Isles of Scilly Sea Defences ES Addendum Non- Technical Summary

Final Report

April 2023

Council of the
ISLES OF SCILLY

Figure 3-1: updated design drawing for Great Porth (Great Par) North of Great Carn (HR Wallingford, 2023)

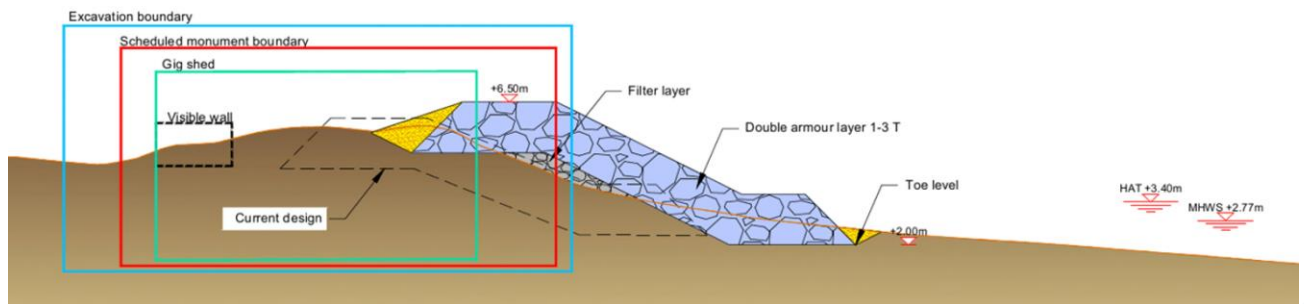
The design of the proposed development at Great Porth (Great Par) North of Great Carn has been altered in response to comments received by Historic England. Comments received relate to concerns surrounding the impact on the Scheduled Monument 'Gig shed on the north coast of Great Porth, Bryher'.

Three alternative designs were developed by HR Wallingford (2023), each of which with a seaward advancement to reduce or avoid overlap with the Scheduled Monument boundary. The preferred design change at Great Porth (Great Par) North of Great Carn includes the seaward advancement of the structure by 4.1m compared to the original design. Initial discussions have been undertaken with Historic England to address issues associated with the presence of the Scheduled Monument. Full details of this updated design will be subject to further investigation of the Scheduled Monument and identification of a preferred mitigation method and compensatory heritage scheme. In addition, it is proposed that the existing ramp be relocated to the north-west area of the existing location.

The revised design will have a greater overall length and volume compared to the current design. Table 3-1 below presents a summary of the key characteristics of the revised design compared to the original design.

Design Option	Seaward advance relative to original (m)	Seaward slope of structure	Depth of toe (mAOD)	Rock size (t)	Crest level* (mAOD)
Original	-	1:2.5	+2.3	1 to 3	+6.0
Revised	4.1	1:2	+2.0	1 to 3	+6.5

Figure 3-2: Updated design drawing for Periglis (HR Wallingford, 2023).

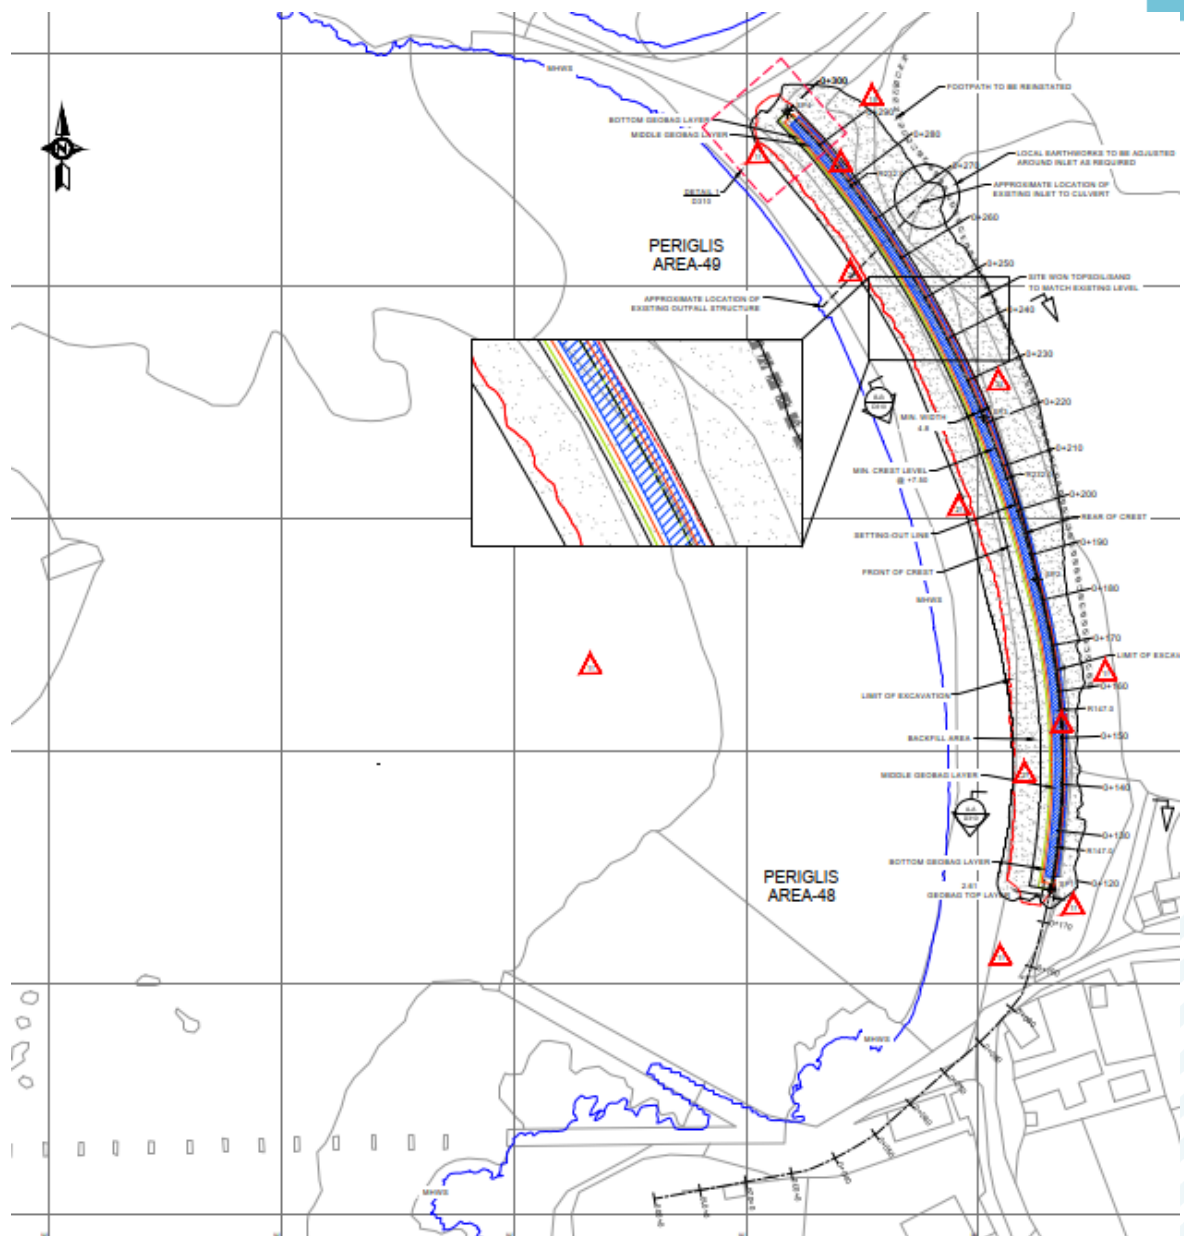
The design of the proposed development at Periglis has been altered in response to comments received by the Environment Agency and Natural England. Comments received related to concerns surrounding the impact on designated habitats and concerns that the design of the proposed works would not provide the intended protection for the drinking water supply and would be prone to undermining and failure in future.

The design has therefore been amended to construct the geobags into the rear of the dune ridge (3m landward) rather than towards the seaward face to avoid disturbance to the shingle ridge frontage and avoid the risk of undermining within the intended design life of the structure.
